SERVICE BULLETIN

EQUIPMENT SERIES: 30L-1

EQUIPMENT TYPE: 30L-1 R-F LINEAR AMPLIFIER

SUBJECT: WIRING CHANGE REQUIRED BEFORE CONVERSION FROM 115 TO 230-VOLT OPERATION IS MADE, USE OF 8-AMPERE LINE FUSES, AND CORRECTION TO INSTRUCTION BOOK DRAWINGS.

Figure 1

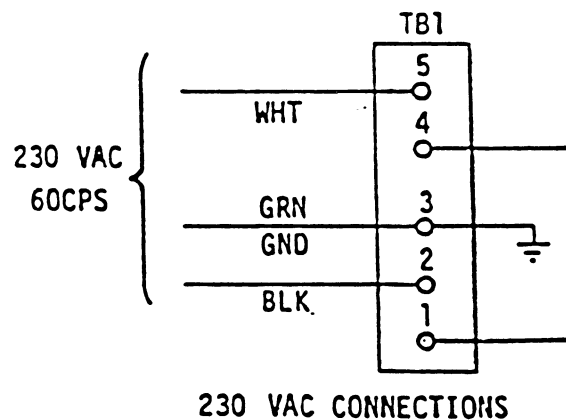
The procedure and schematic for converting operation of the unit from 115 to 230-volts, as detailed in the 5th edition of the 30L-1 R-F Linear Amplifier Instruction Book, dated 15 June 1962, is in error. These errors are corrected in the 6th edition of the above referenced instruction book, dated 15 June 1964. Before conversion is attempted the wiring changes detailed below must be made. After these changes have been made, the conversion can be made by changing the jumper wires on TB1 as shown in figure 1.

Procedure for correcting TB1 wiring to allow conversion from 115 to 230-volt operation:

1. Remove a-c power cord from the primary power source.
2. Lift the cabinet lid and remove the two Phillips-head screws located on the front panel rim.
3. Remove the four feet and the Phillips-head screw that is located between the rear feet.
4. Remove amplifier chassis from cabinet. The easiest way to do this is to place amplifier panel down on a padded surface.
5. Remove the screws from the bottom panel and both end panels of the amplifier. Lift out the bottom shield.
6. Move the white wire from the power cord from terminal 1 to terminal 2 on terminal strip TB1.
7. Move the lead of capacitor C4 from terminal 1 to terminal 2 of TB1.
8. Reassemble unit and return to operation. (Conversion from 115 to 230-volt operation and vice versa now can be made by connecting the jumper units on terminal strip TB1 as shown in figure 1.)
